LANDMARK COMMISSION REGULAR MEETING **Public Notice**

June 3, 2024, Briefing at 10:00 A.M. and the Public Hearing at 1:00 P.M. Dallas City Hall, 6ES Council Briefing Room and Videoconference

AGENDA

CURRENT DOOR DESIGN

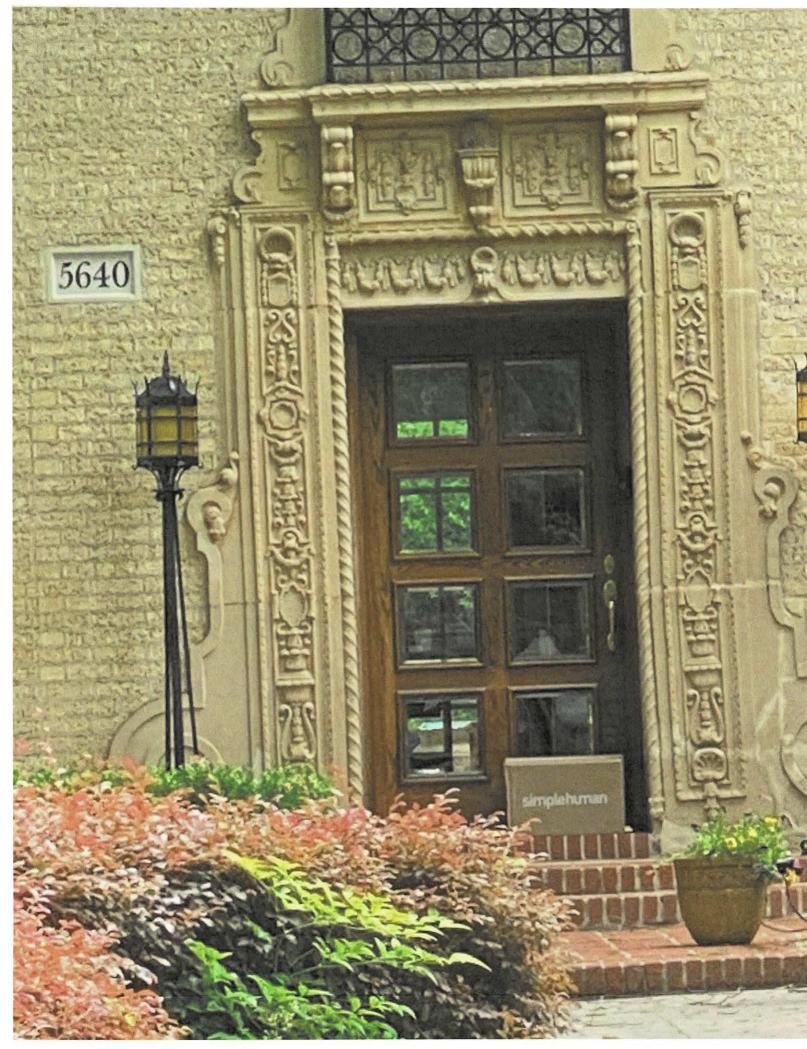
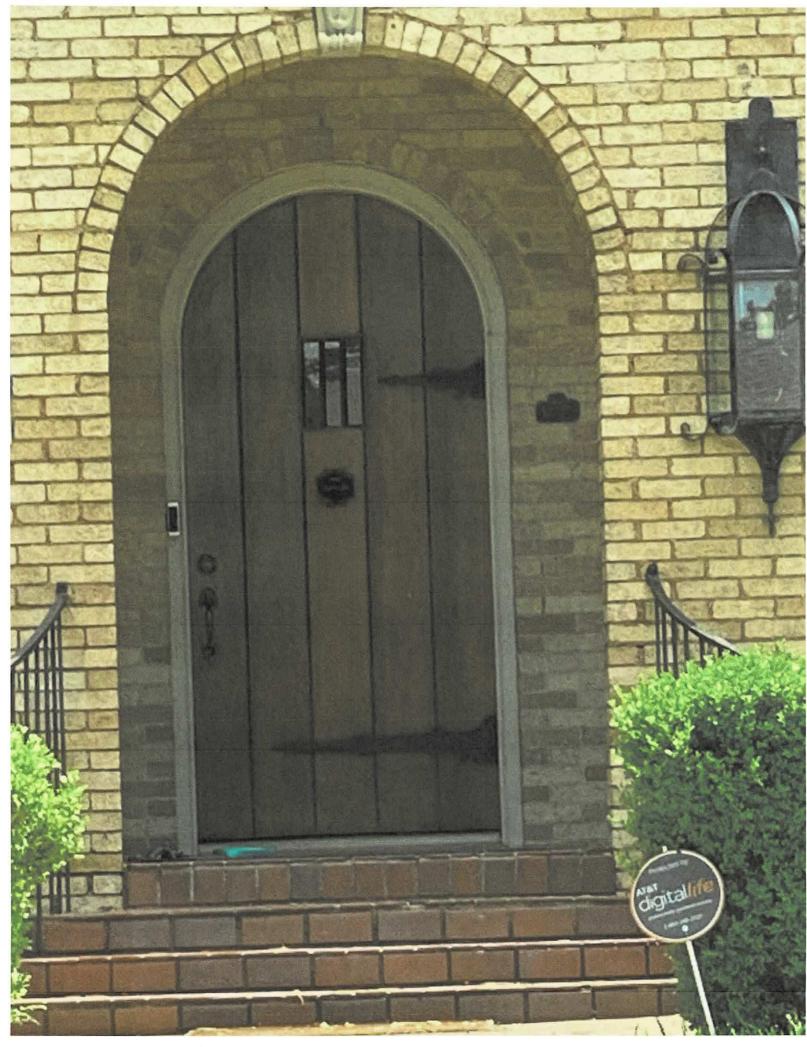
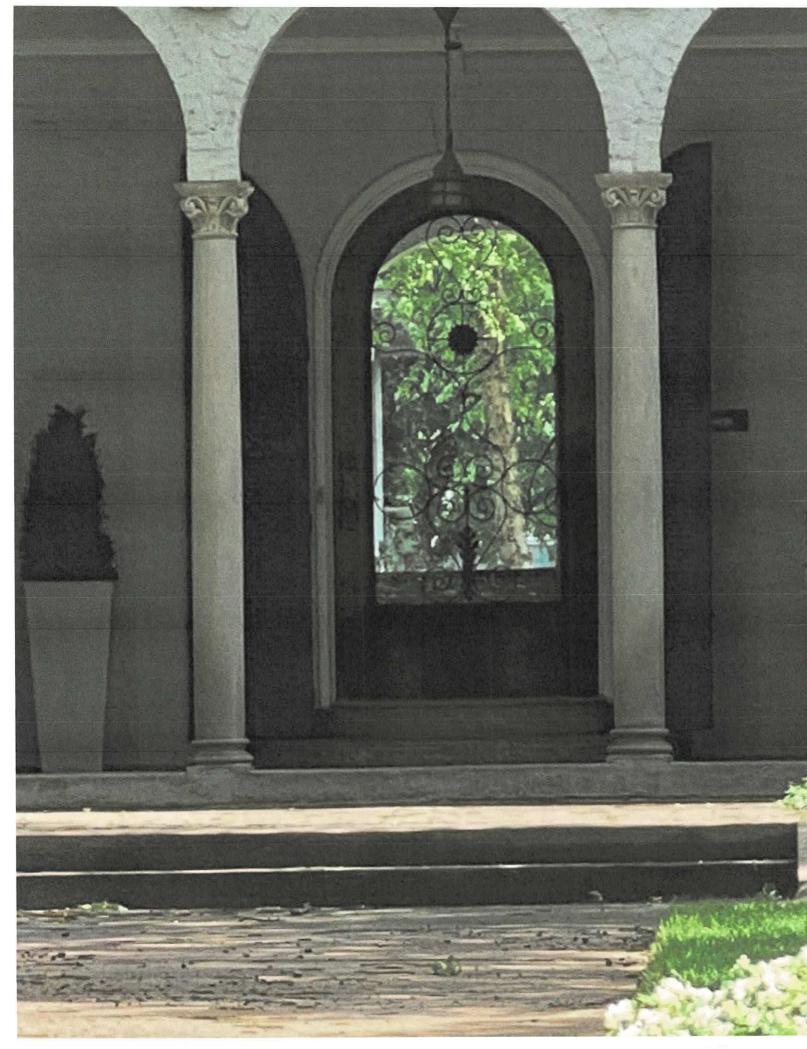
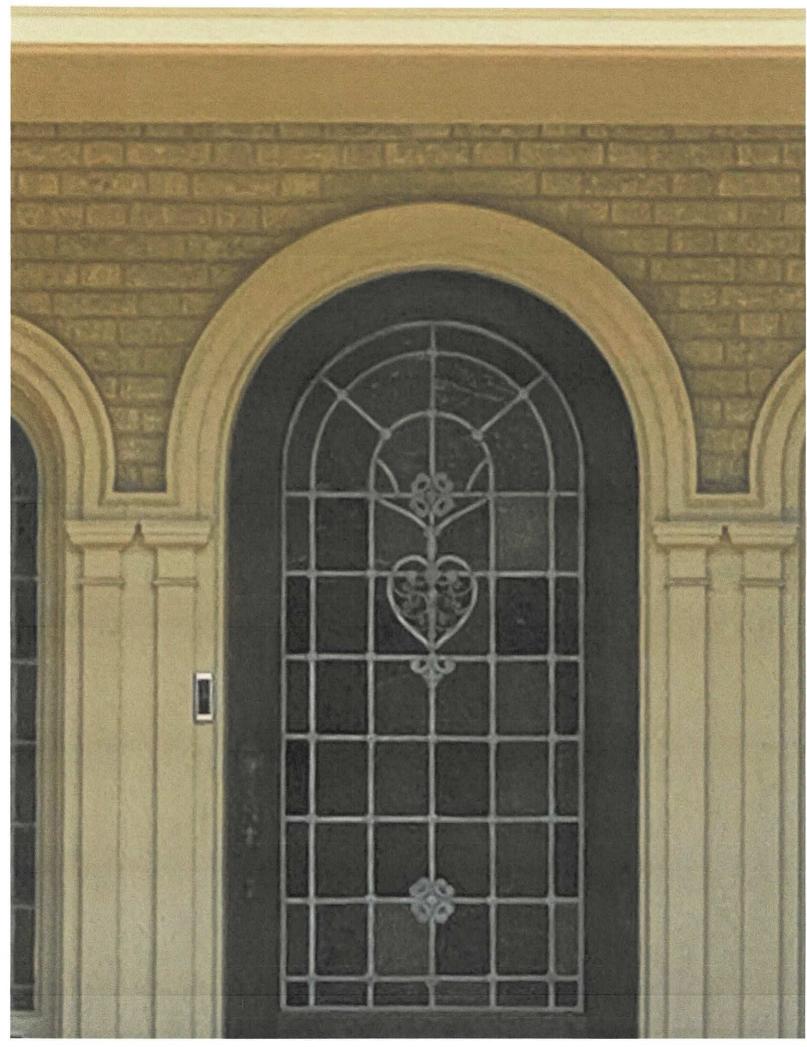
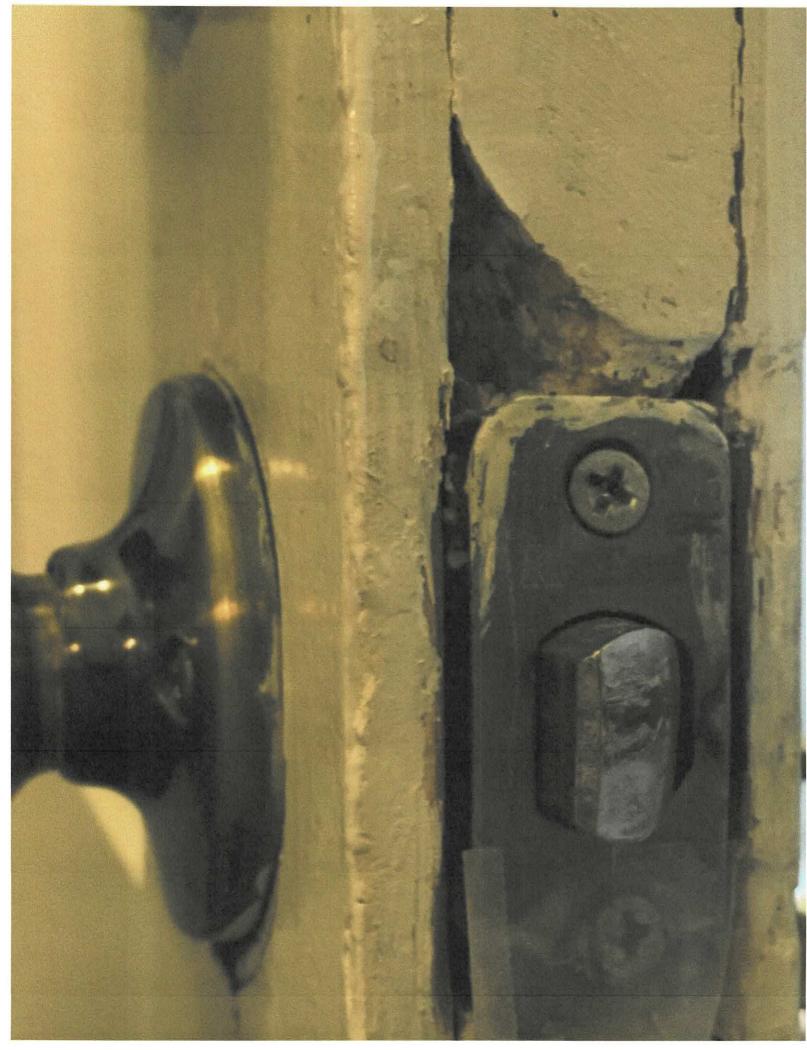
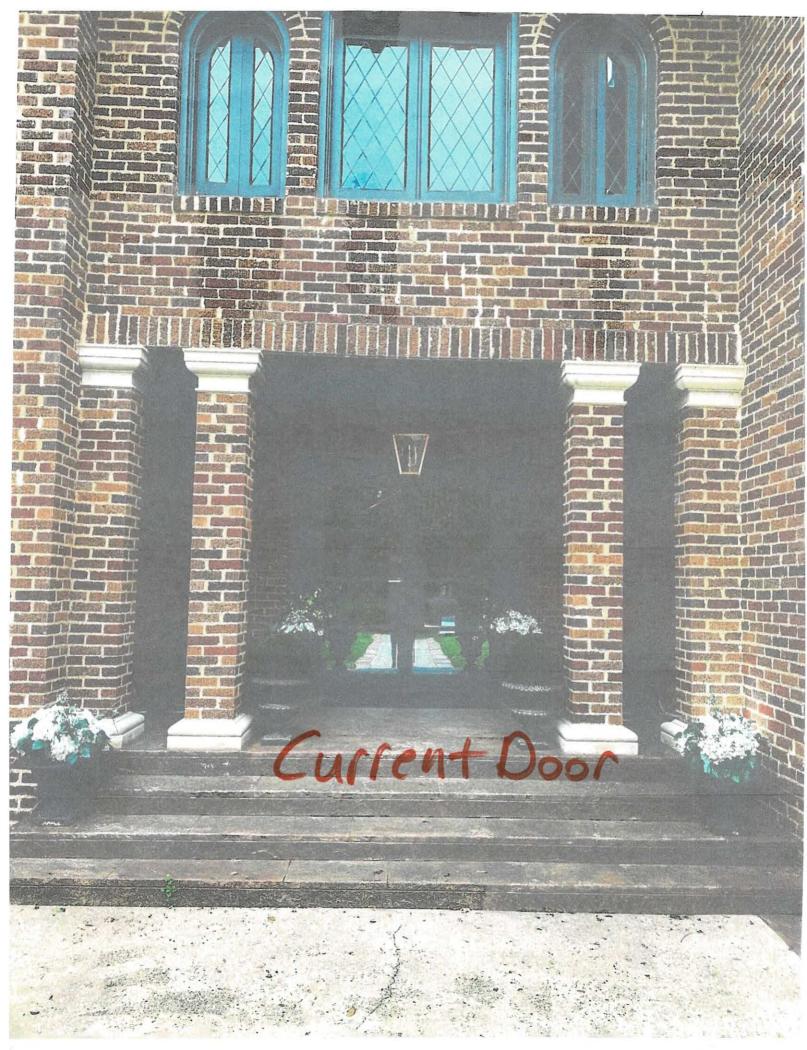
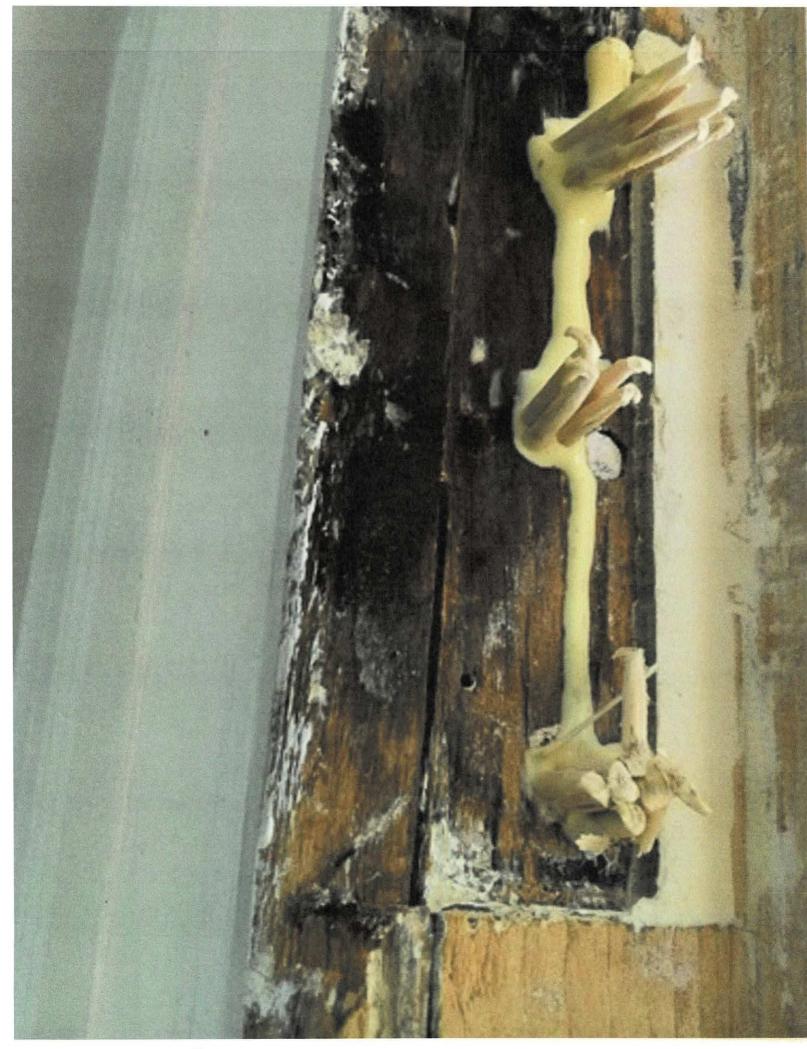
That the request for a Certificate of Appropriateness to replace single front door and two side lights with a set of double metal French doors be denied without prejudice. The proposed work is inconsistent with preservation criteria Sec. 51P-63.116(1)(P)(i) and (vi); the standards in City Code Section 51A-4.501(g)(6)(C)(i) for contributing structures; and the Secretary of the Interior's Standards for Rehabilitation.

That the request for a Certificate of Appropriateness to replace single front door and two side lights with a set of double metal French doors be denied without prejudice.

EAST (FRONT) PORCH ELEVATION 1/4" = 1'-0" 〔1〕

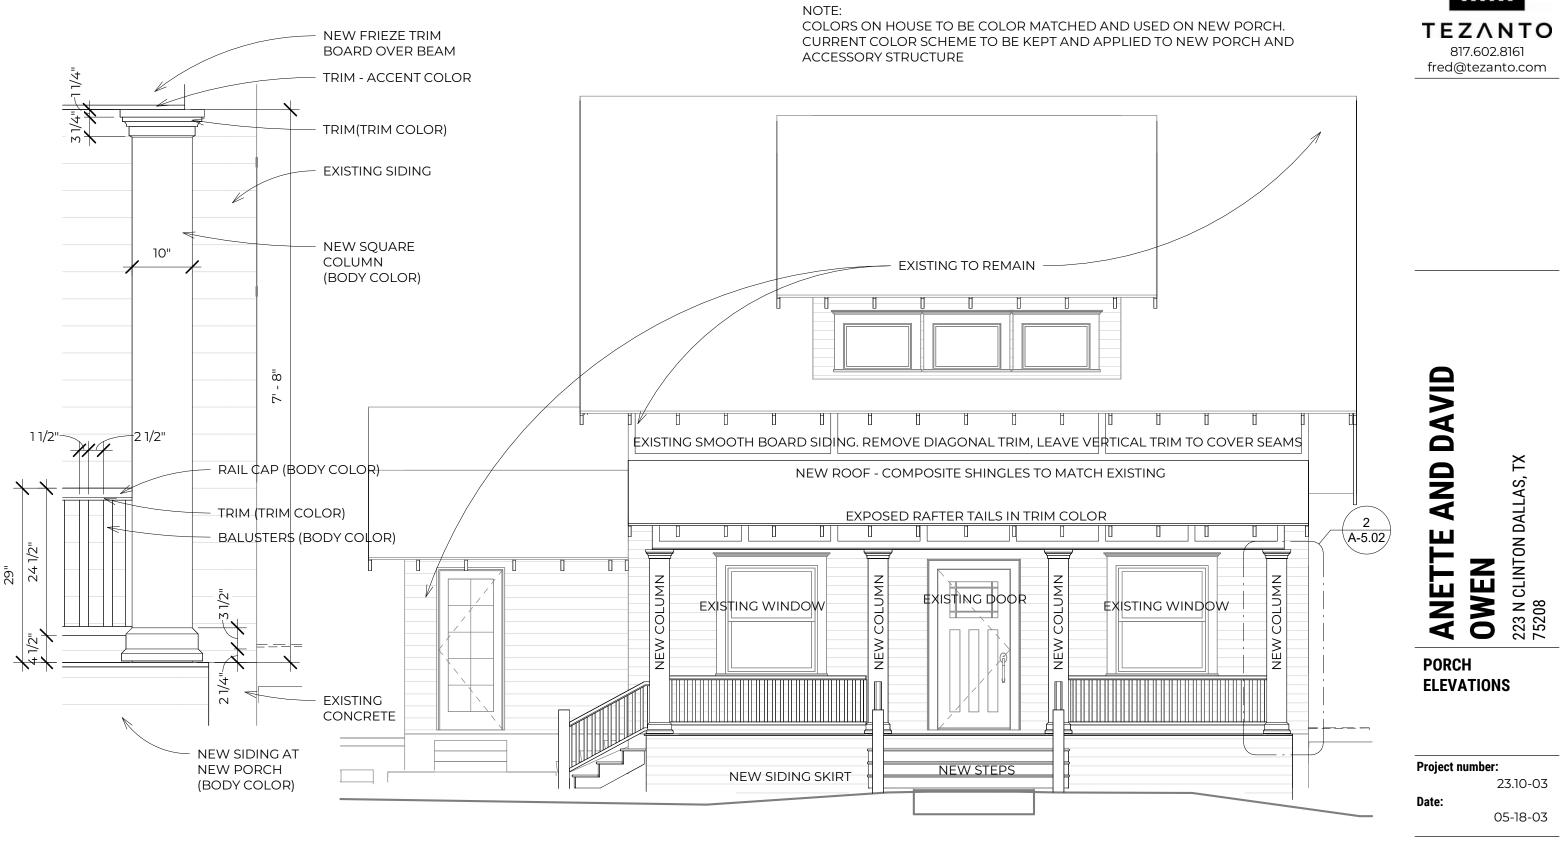
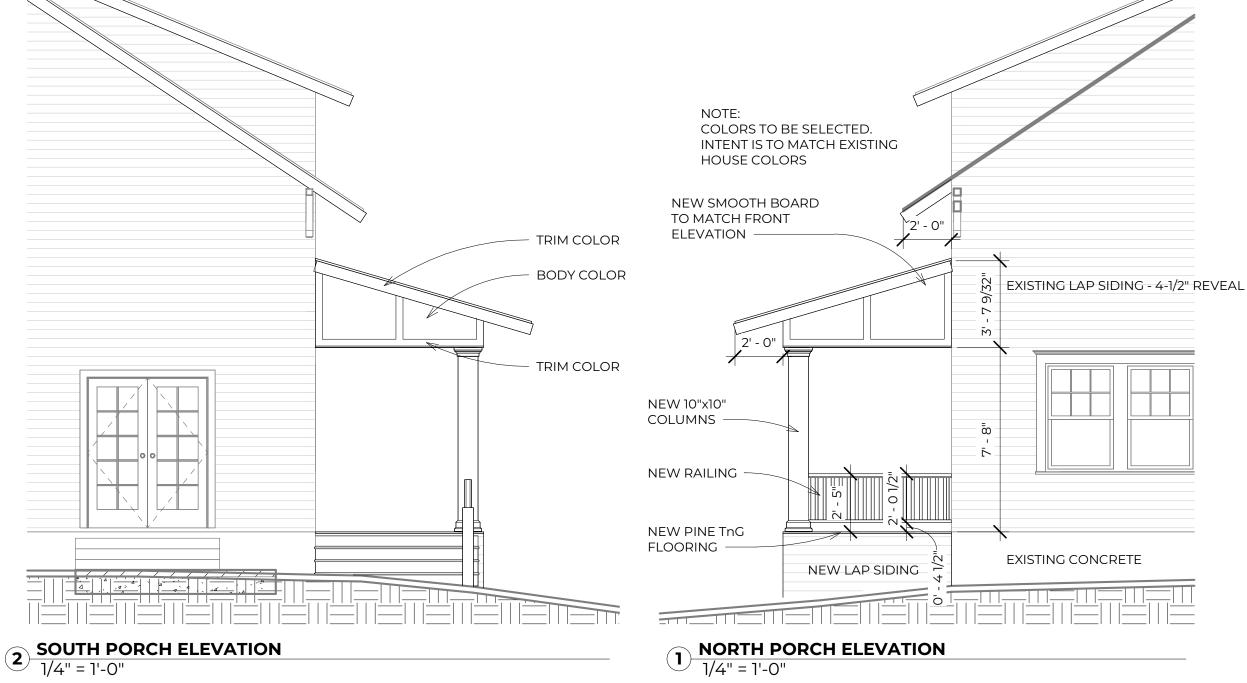
- That the request for a Certificate of Appropriateness to construct a new two-story accessory structure in the rear (west) yard. No quorum. General comments. Generally supportive of accessory structure with comments. Add window trim on garage. Roof and paint colors. Consider changing outdoor stairs on accessory structure. Consider changing back wall (balustrade) of the accessory structure. (NOTE: The applicant revised the plans based on task force recommendations.)
- 2. That the request for a Certificate of Appropriateness to reconstruct a front porch on the front facade of the main structure. No quorum. General comments. Supportive of front porch construction. Call out railing details on front porch.
